TO: All Bidders
FROM: City of Cambridge
DATE: January 24, 2014
RE: File No. 5849C –Dr. Martin Luther King Jr. School Construction
Project- Addendum NO. 5

Addendum No. 5

Project: Dr. Martin Luther King Jr. School Construction Project

Regarding: Bid Addendum 5 – Volume 1

PROJECT NO. 47931.00
 SCALE: 1/8" = 1'-0"
 SHEET: P100.1
 REFERENCE:
 DWG. NO.: *PSK100.1-1*

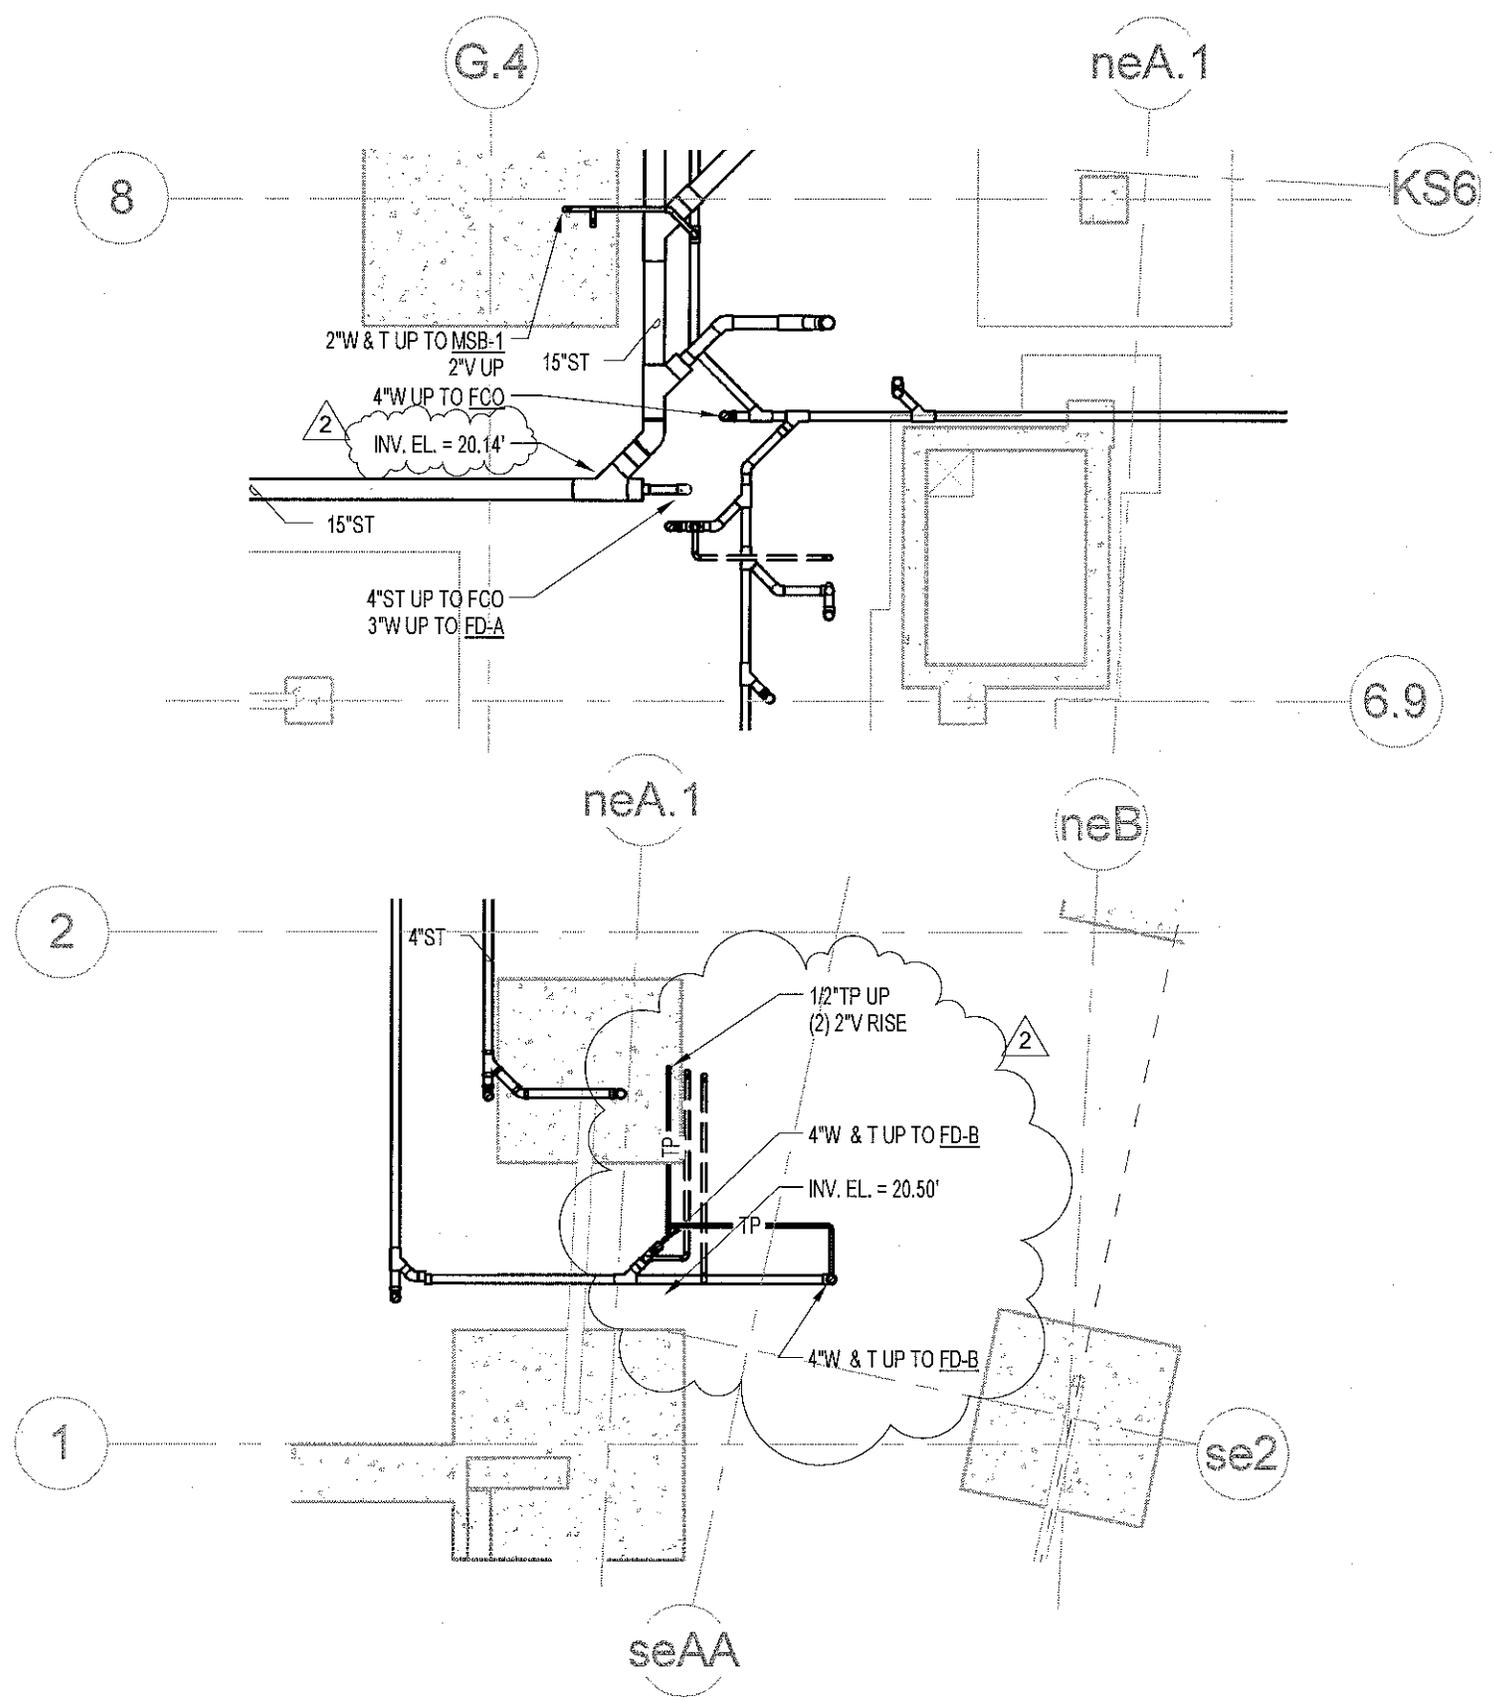
#	DISCIPLINE	ISSUE	PROJECT MANUAL
1	Plumbing	None Submitted	None Provided
#	DISCIPLINE	ISSUE	DRAWINGS
01	Plumbing	Subject: References: Description:	Underground Storm P100.2 Clarified storm pipe sizes and inverts
02	Plumbing	Subject: References: Description:	Underground Storm P100.4 Clarified storm pipe routing. Added trap primer piping
03	Plumbing	Subject: References: Description:	Storm Piping P110.2 Clarified storm pipe routing, sizing. Coordinated open end drains for condensate.
04	Plumbing	Subject: References: Description:	Legend PSK001-2 Added symbol for backwater valve
